1 APPLICATION SUMMARY

Application information	
Address	2 Highlands Street, STAPYLTON QLD 4207 & 2 Fairway Street, STAPYLTON QLD 4207
Lot and plan	Lot 204 SP316171 & Lot 205 SP316171
Site area	2 Highlands Street: 37,660m ² 2 Fairway Street: 42,320m ² (access easement only)
Type of development and proposed use	Combined application for a Material change of use (Warehouse x 2), Reconfiguring a lot for an access easement, and Operational works for a change to ground level.
Categories of development and assessment	Code assessment
Properly made date	24 December 2024
Decision due date	11 September 2025
Applicant and Applicant's consultancy team	FPI Queensland Pty Ltd – Applicant Gassman Development Perspectives – Planning Consultant Acoustic Works – Acoustic Consultant Rytenschild - Traffic Consultant
Owner details	Australand Industrial No. 89 Pty Ltd
City Plan version	Not applicable
Zone / Precinct	Low impact industry, Future low impact industry precinct, Medium impact industry, Future medium impact industry, High impact industry.

The purpose of this report is to assess an application for a Development for a Material change of use to establish a Warehouse, Reconfiguring a lot for an acc

Figure 2: proposal site plan (Source: Applicant submitted material)

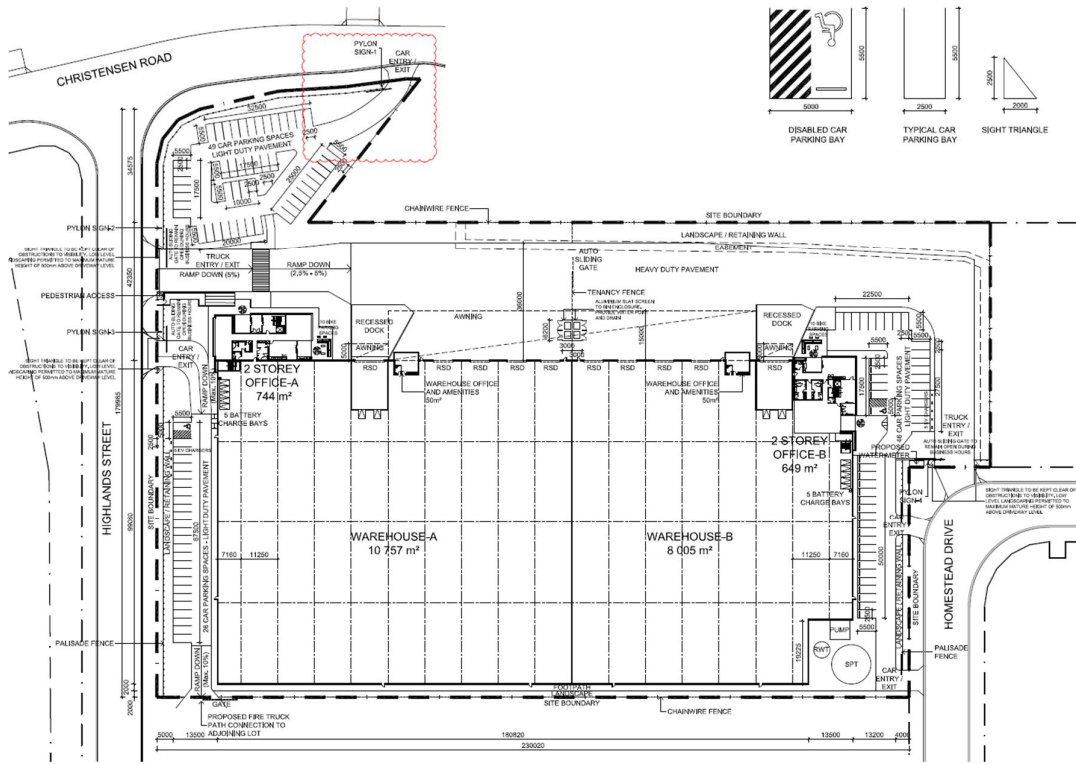
The proposed development includes staff/visitor car parking areas in front of the ancillary office entrance. As such the proposed development does not comply with Acceptable Solution AS20.2 and needs to be assessed against Performance Criteria PC20 of the M38 Industrial Estate Place Code.

The proposed development includes two large Warehouses with an ancillary office space. As the office space is intended as the entrance for staff and visitors to the site, the car parking areas are located closely to the office entrance. To ensure that areas intended for the public and loading bays are kept separate, the building design and site layout is considered safe and practical while maintain a high quality industrial design.

The proposed development seeks to provide car parking including employee parking at the front of the site which conflicts with Acceptable Solution AS51.1 requiring parking areas to be situated to the rear or the side of the site. As such assessment is required against Performance Criteria PC51.

Figure 8: Possible additional car parking area (Source: Applicant submitted material)

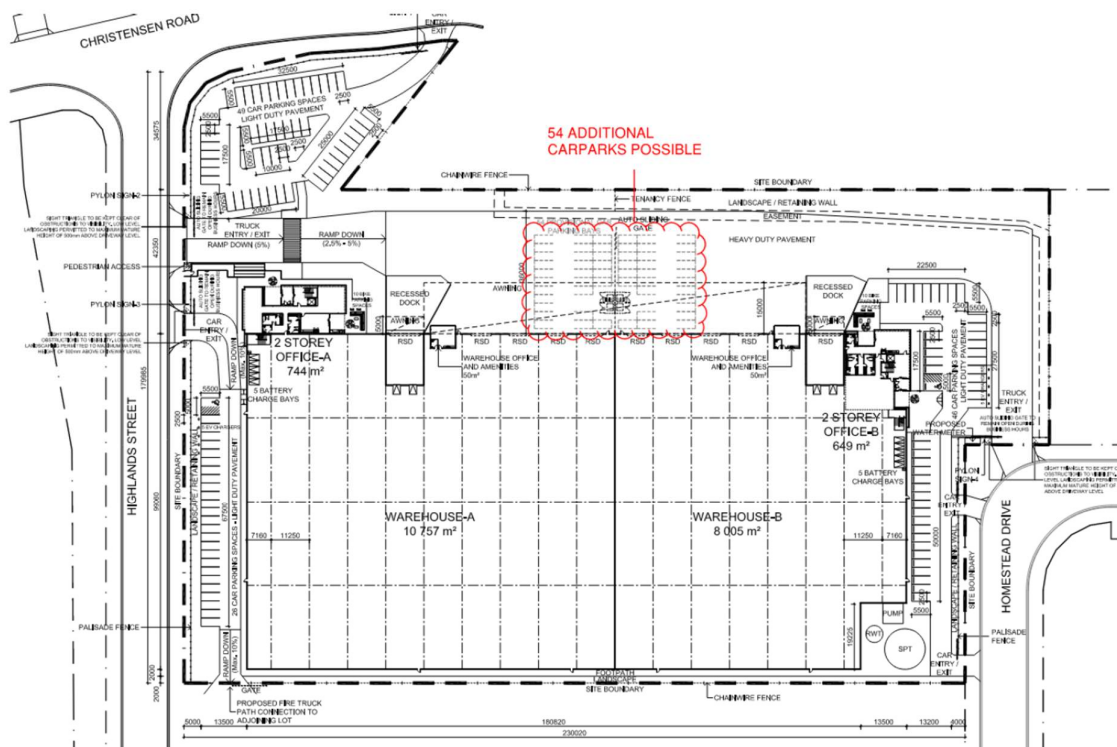
- As the proposed industrial building is capable of supporting other industrial uses as envisioned within Precinct B of the Vantage Industrial Estate, the applicant has demonstrated that additional car parking can be provided within the site should a future user have a higher car parking demand (below image). An additional 54 car parking spaces are able to be supported adjacent the excess loading bays. It is anticipated that if a manufacturing use was to occupy the tenancy requiring more staff, lesser logistical activities would be required allowing for the reduction in accessible loading bays.

The development proposal is considered to demonstrate that the car parking supply will sufficiently cater for an intended logistical user, with the ability to provide additional staffing should manufacturing activities require a higher car parking provision.

On this basis, compliance with Performance criteria PC8 has been demonstrated.

Figure 9: Excerpt of site plan illustrating the pedestrian route from the car parking location to the ancillary office area (Source: Applicant submitted material amended by City officer)

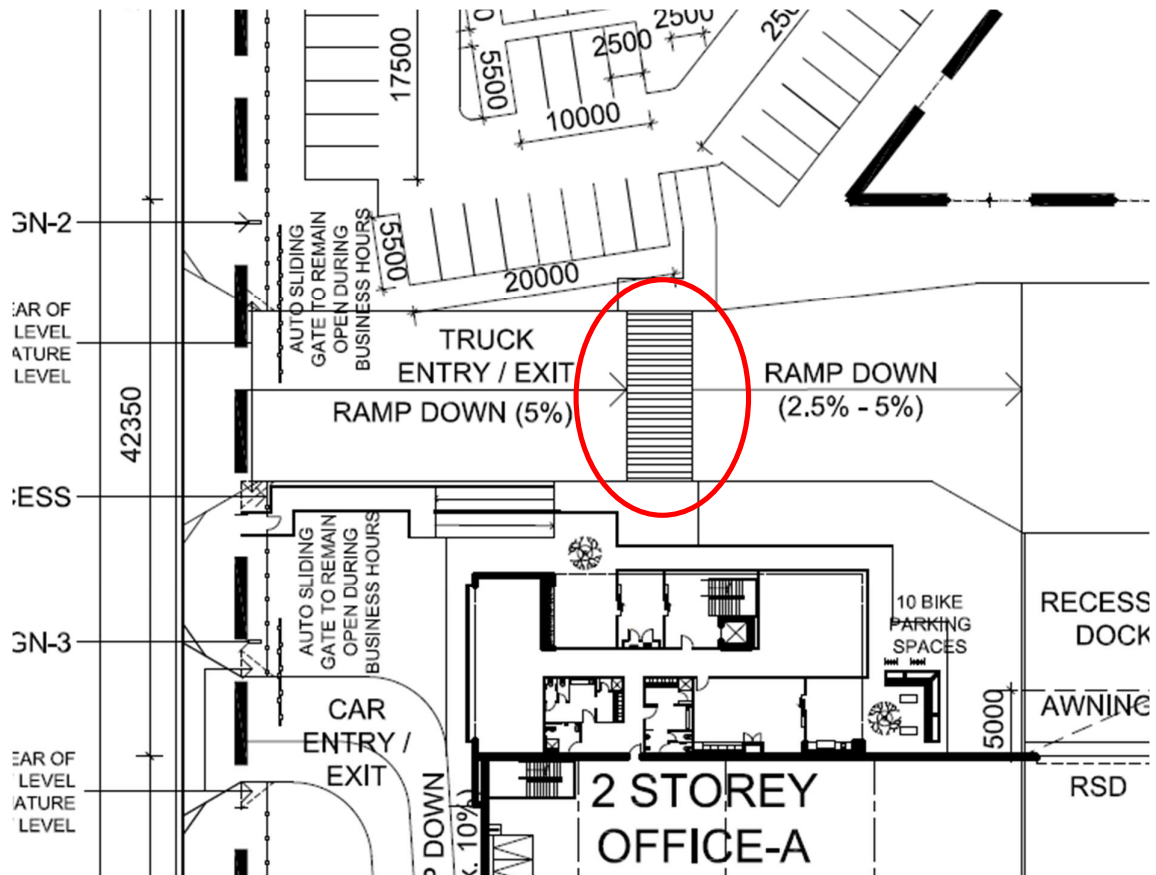
The staff vehicle parking areas are located separate to the heavy vehicle access points. The layout design situates a total of 72 car parking spaces adjacent the ancillary offices, minimising potential for conflicts between vehicles and pedestrians within the site. The western most car park facilitates 49 carparking spaces, separated from the ancillary office by the truck entry/exit location. To manage conflicts between heavy vehicles and pedestrian activity within the site, a pedestrian crossing is located across the driveway ramp approximately 28m within the site (below image).

The location of the pedestrian crossing internal to the site provides suitable visibility for heavy vehicles entering the site with sufficient space for the largest service vehicle to stand within the site when yielding to internal pedestrian movements. Further, landscaping is provided around the

extent of the car parking areas guiding pedestrians to the designated crossing locations reducing risk of conflict.

Based on the above assessment, the proposed access arrangement is considered to comply with Performance criteria PC43 and PC55 of the M38 Industrial Estate Place Code, and Performance criteria PC10 and PC18 of the Car Parking, Access and Transport Integration Constraint Code.
